PROJECT NAME: Construction Work for Wayne Johnson Community Center

BID NO: B191006

RE: ADDENDUM #1

Subject: **MOLD REMEDIATION PROTOCOL**
Wayne Johnson Community Center/ Carbide Park
4102 Main Street
La Marque, Texas

SHEET NO. A101

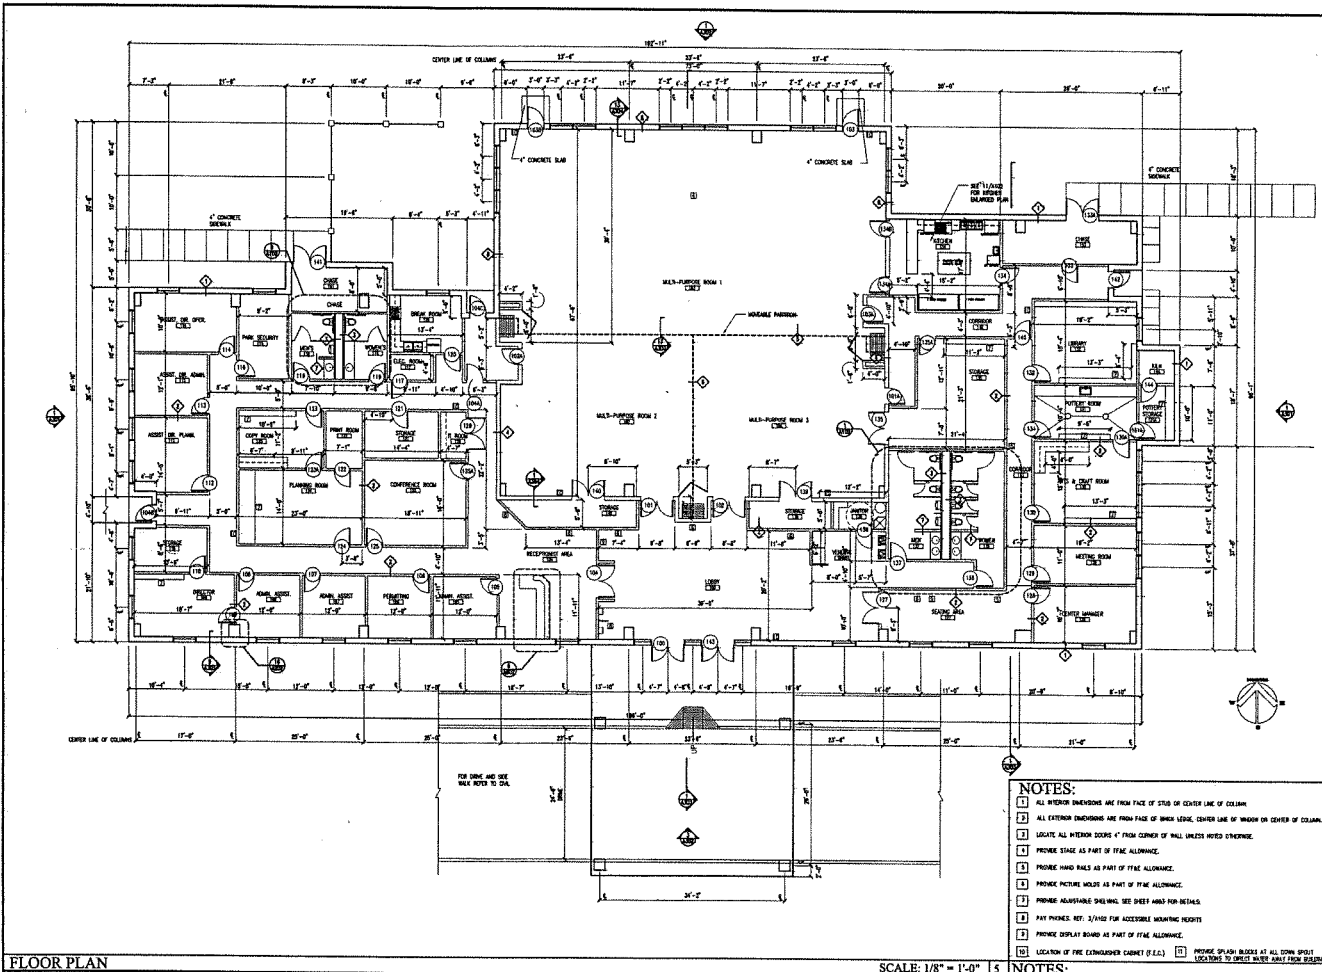
Question #1: *Do you have a floor plan drawing of the building that we can use to help us identify work and possible restraints as we walk the site prior to bidding?*

Response: Attached you will find the construction plan for the Wayne Johnson Community Center.

REMEDIATION SCOPE OF WORK DRAWINGS

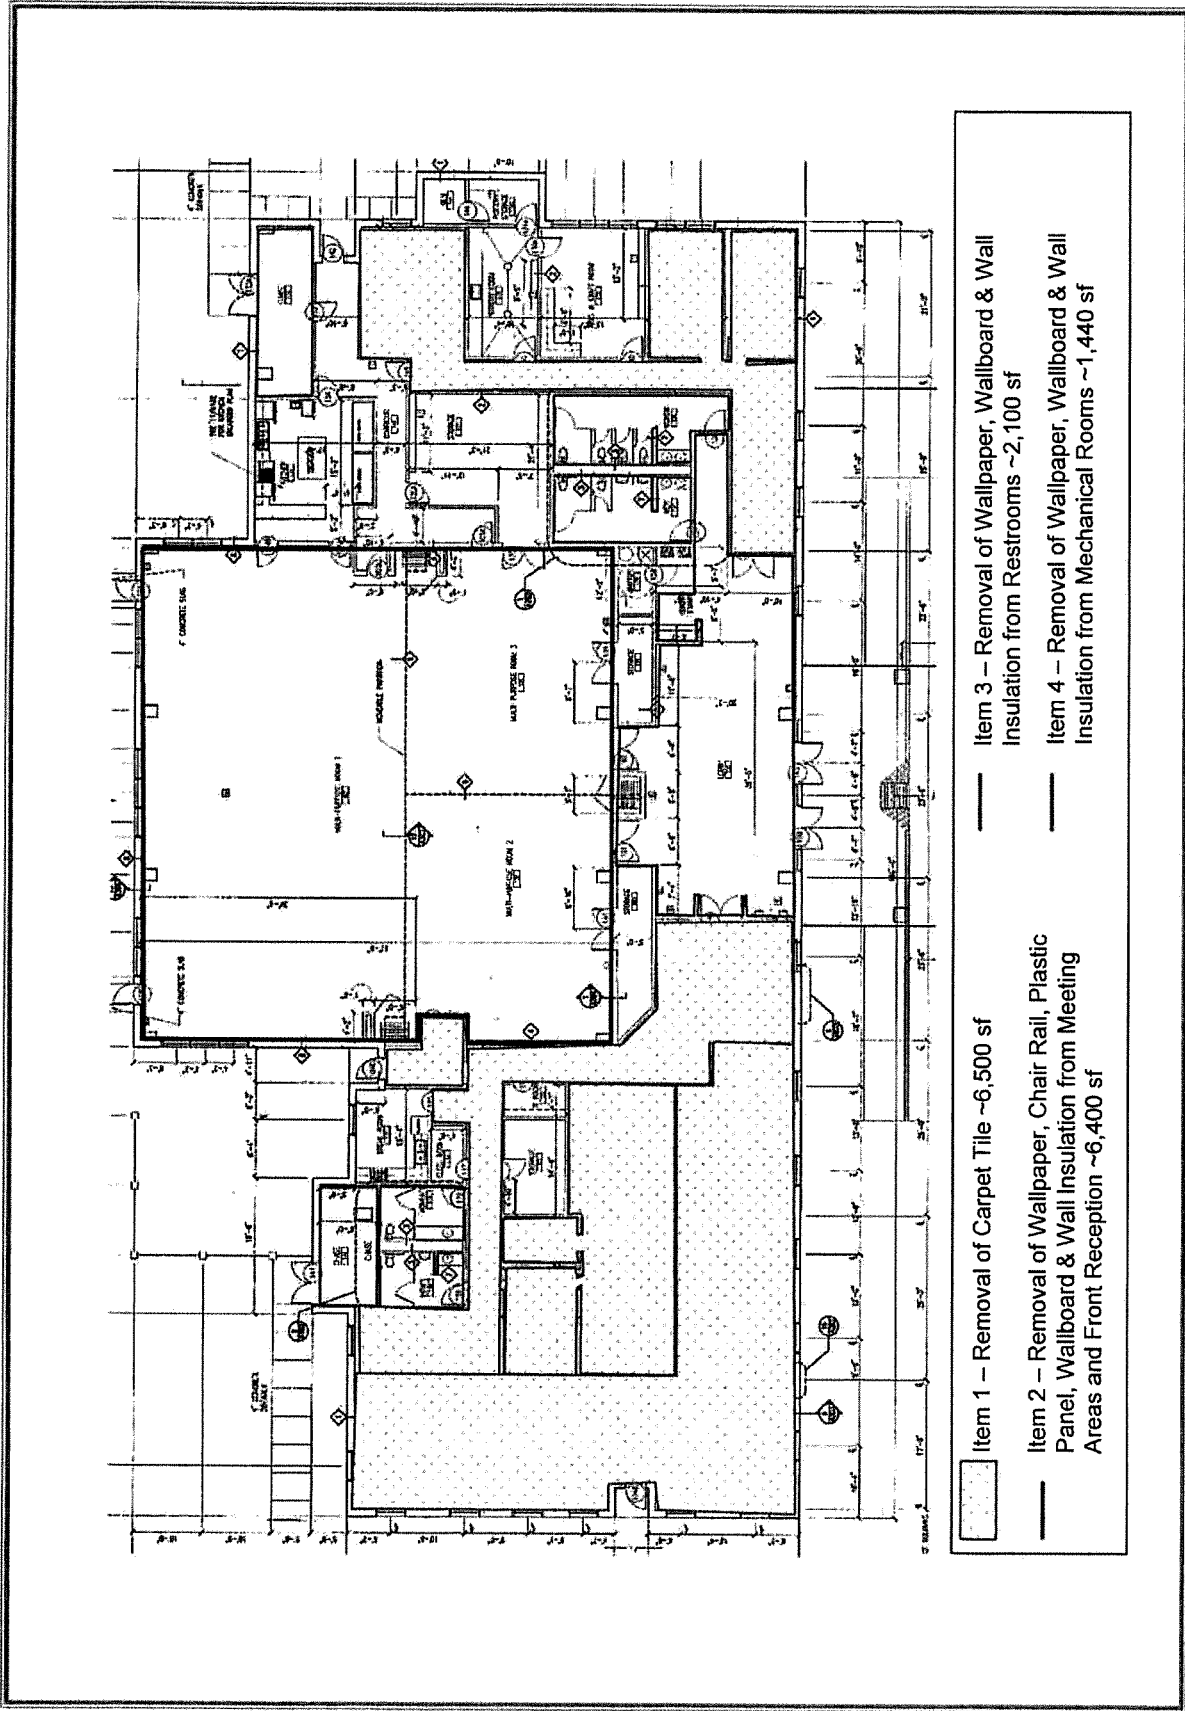
- Item 1 – Removal of Carpet Tile ~6,500 sf
- Item 2 – Removal of Wallpaper, Chair Rail, Plastic Panel, Wallboard & Wall Insulation from Meeting Areas and Front Reception ~6,400 sf
- Item 3 – Removal of Wallpaper, Wallboard & Wall Insulation from Restrooms ~2,100 sf
- Item 4 – Removal of Wallpaper, Wallboard & Wall Insulation from Mechanical Rooms ~1,440 sf
